**Proposal #12: 1150-76-71, WISC 2022489  
Green Bay - Oconto  
Little Suamico River Bridge  
USH 41  
Oconto County**

This is Addendum No. 01, which provides for the following:

Addendum No. 01  
 ID 1150-76-71  
 Revised Sheet 38  
 July 28, 2022

Addendum No. 01  
ID 1150-76-71  
Revised Sheet 103  
July 28, 2022

SHEET NO: 38

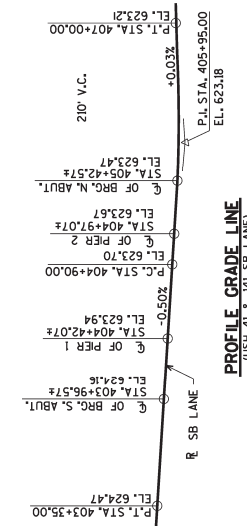
Revised Plan Sheets	
Plan Sheet	Plan Sheet Title (brief description of changes to sheet)
38	Miscellaneous Quantities (revised quantity for guardrail items)
103	Structure B-42-19 (revised quantity for Bar Couplers No. 5)

CATEGORY	STATION	TO	STATION	LOCATION	REMOVING GUARDRAIL	LF	MGS GUARDRAIL 3	LF	MGS THRIE BEAM TRANSITION	LF	SPV 0090 01 SALVAGE AND REINSTALL GUARDRAIL	LF
<b>STAGE 2</b> 0010	403+75	-	407+00	USH 41, SB, RT	-	-	-	-	-	-	12	
	405+46	-	407+00	USH 41, SB, RT	152	112.5	39.5	39.5				
				USH 41, SB, RT	-	-	-	-	-	-	12	
				STAGE 2 SUBTOTALS	152	112.5	39.5	39.5			24	
<b>STAGE 3</b> 0010	405+68	-	406+97	USH 41, SB, LT	127	87.5	39.5	39.5				
				USH 41, SB, LT	127	87.5	39.5	39.5			0	
				STAGE 3 SUBTOTALS	127	87.5	39.5	39.5			0	
				TOTAL 0010	279	200	79	79			24
